Official Interpretation No. 1-85

DATE: October 30, 1985

SUBJECT: State Building Code Section 108.5.1

780 CMR: STATE BOARD OF BUILDING REGULATIONS AND STANDARDS
THE MASSACHUSETTS STATE BUILDING CODE

Section view of a “two room” layout with the ceiling-mounted or wall-mounted smoke detector (■) shown in the room on the left and the kitchen or bathroom represented by the room on the right.

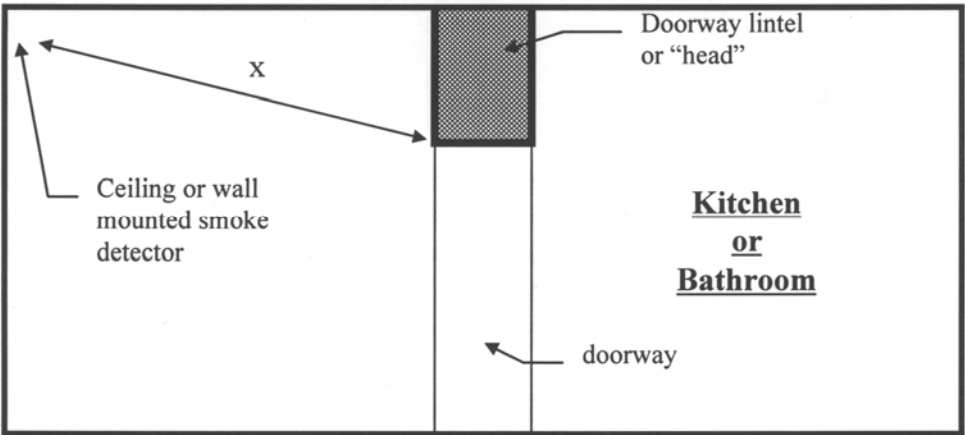
Answer 3: Refer to the sketches and note that the 20 foot rule applies to smoke detectors only on the same floor as kitchens or bathrooms containing a tub or shower and that the 20 foot distance from the smoke detector (ceiling or wall mounted) to the kitchen or bath shall be “true length”, measured from:

the centerline of the smoke detector to the nearest edge, front face of the doorway separating the kitchen or bath from the area in which the smoke detector is located (in “two room” layouts), and;

Plan view of a “two room” layout with either a ceiling-mounted or a wall-mounted smoke detector (■) shown in the room to the left and the kitchen or bathroom represented by the room on the right.

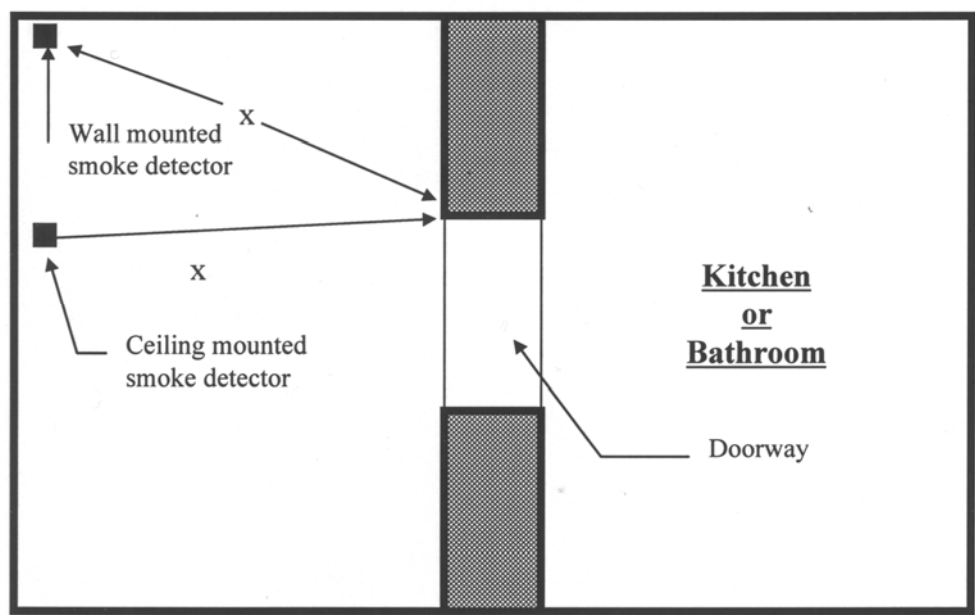
in “open plan” areas where no doorway separates the kitchen from the detector, the 20 foot rule shall be the shortest, “true length” 20 foot distance measured from centerline of ceiling-mounted or wall-mounted smoke detector to nearest edge of fixed smoke-producing appliance (stove, oven, broiler, etc.--note that movable appliances and/or microwave ovens are not to be considered relative to the 20 foot distance).

If true length of “x” is less than or equal to 20 feet, then a photo electric smoke detector must be utilized. The true length of “x” is the actual distance from the centerline of the ceiling-mounted or wall-mounted smoke detector to the nearest edge of detector-side, front face of doorway.
